SUPPLEMENTAL REPORT

Project: Nick DelleDonne, President
Dupont East Civic Action Association, (DECAA)
Masonic Temple Project Zoning Appeal
1733 16th St. NW, Washington DC

We respectfully submit the following additional conclusion with regard to the modified rear yard configuration being proposed by the developer for the 1733 16th St. NW, Washington DC, Masonic Temple Site.

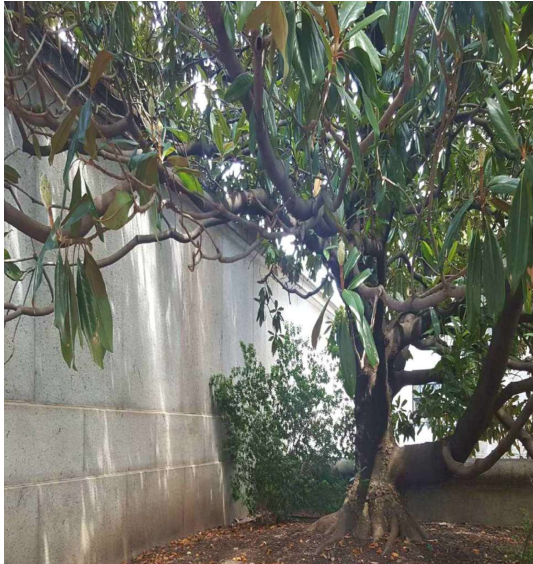
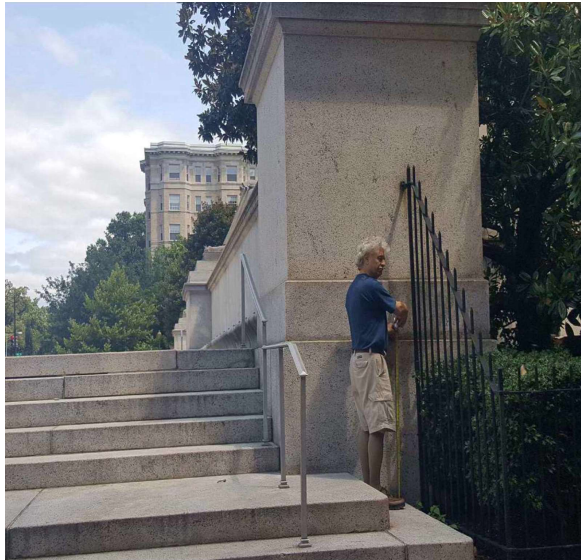
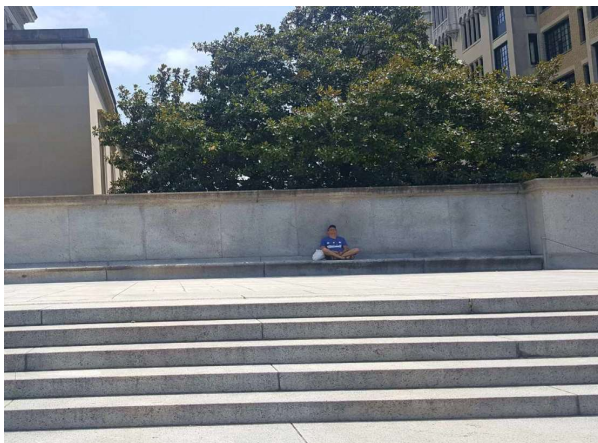
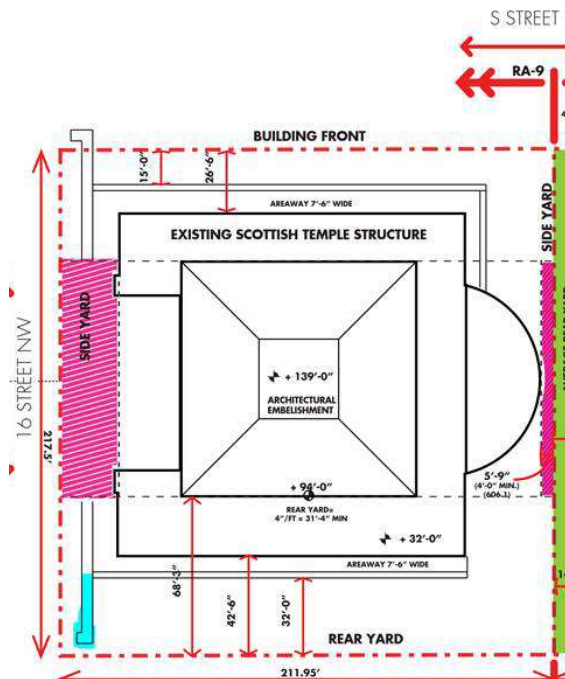
Due to the location of the existing stone wall and column south of the Temple in the proposed rear yard, the proposed reorientation of the rear yard results in a clear violation of 11-B DCMR § 100.2 AND 11-B DCMR § 324.1

Clearly the existing stone wall and column south of the Temple occupy the rear yard, they exceed 4'-0" in height, they do not retain soil or resist a lateral load, they are not necessary to support a stair, nor do they constitute a fence.

The modification of the site configuration to relocate the rear yard to the South clearly violates the provisions for the rear yard requirement.
